Environmental Defense Institute

Keep Yellowstone Nuclear Free

**RE: Preliminary Comments on U.S. Department of Energy Class 3 Modified Permit to the Volume 14 for the Idaho Nuclear Technology and Engineering Center (INTEC) at the Idaho National Laboratory, Permit Number EPA ID No. ID4890008952I
INTEC Liquid Waste Management System and the Integrated Waste Treatment Unit.
IDEQ Public Notice of Intent 1/26/07 to approve Class 3 Permit Modifications of Volume 14, Docket Number 10HW-0701.**

FIGURE 2-4.
Current INTEG high-level waste system
simplified flow diagram.

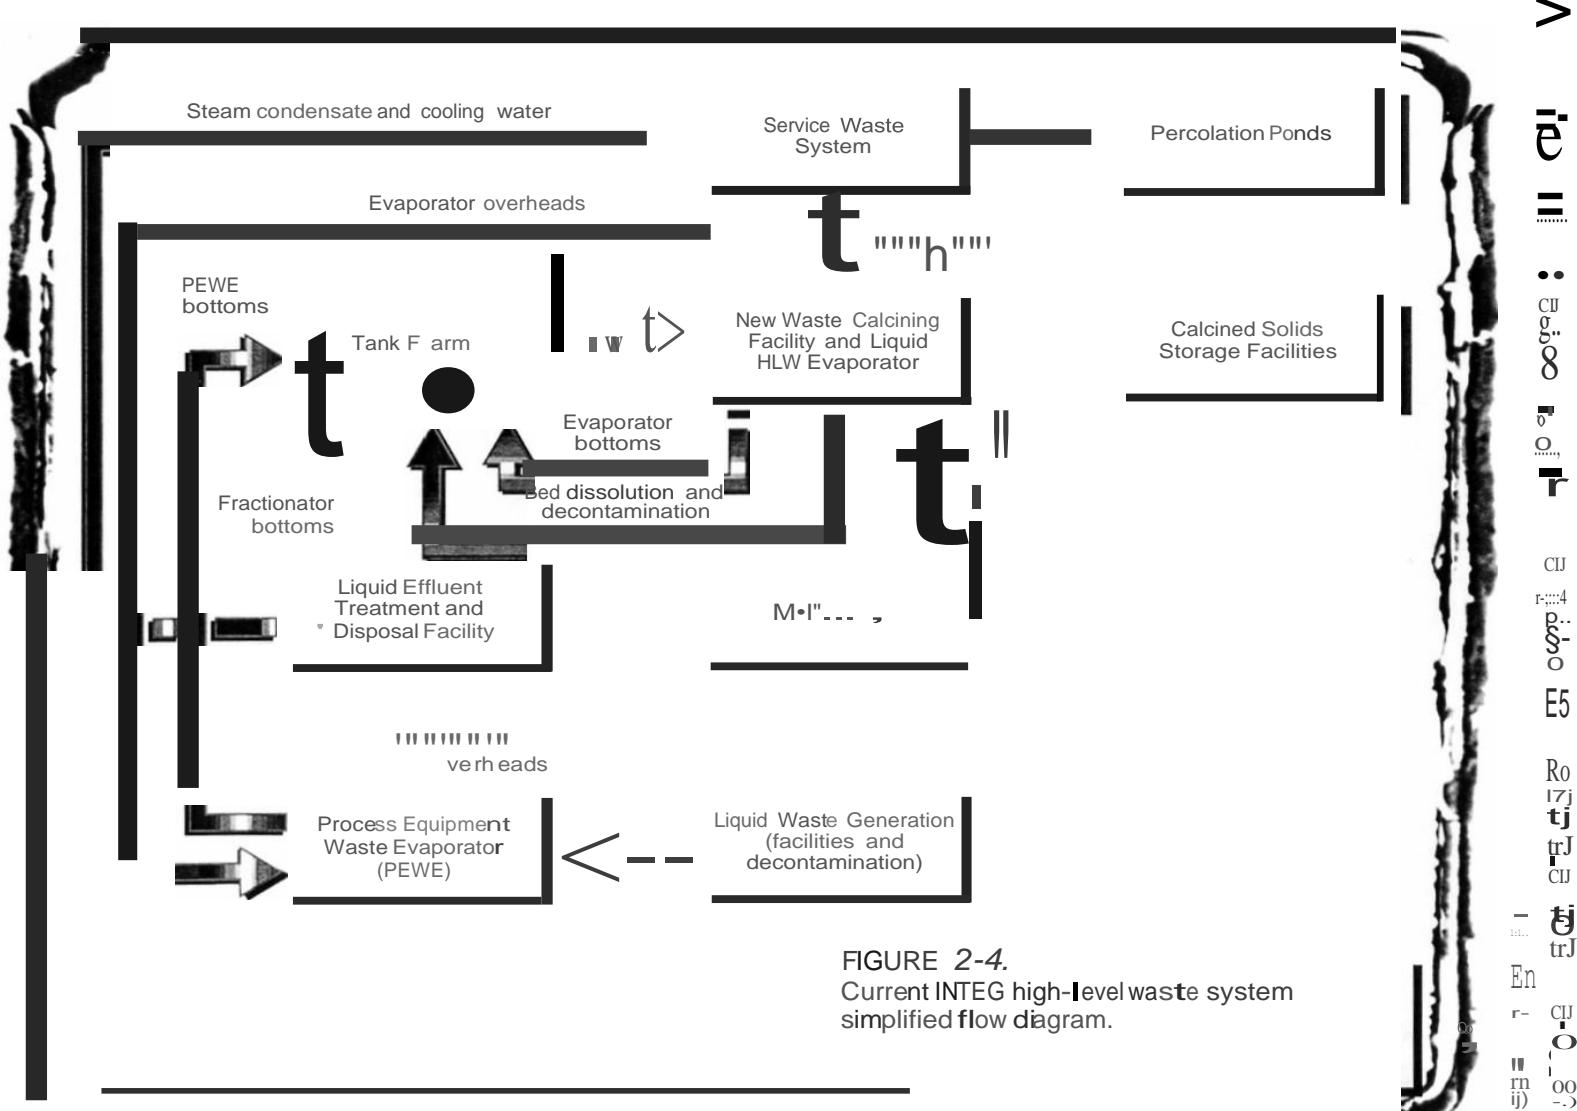
The DOE HLW &FD EIS (DOE/EIS-0287D) page 1-13 (Figure 1-6) and DOE/EIS-0287 Final page 2-11 (figure 2-4) clearly shows the High-level Liquid Waste Evaporator also housed in the New Waste Calciner building, and now called the ETS, emissions go directly to the INTEC main stack.⁷¹ See Attachment C Schematic.
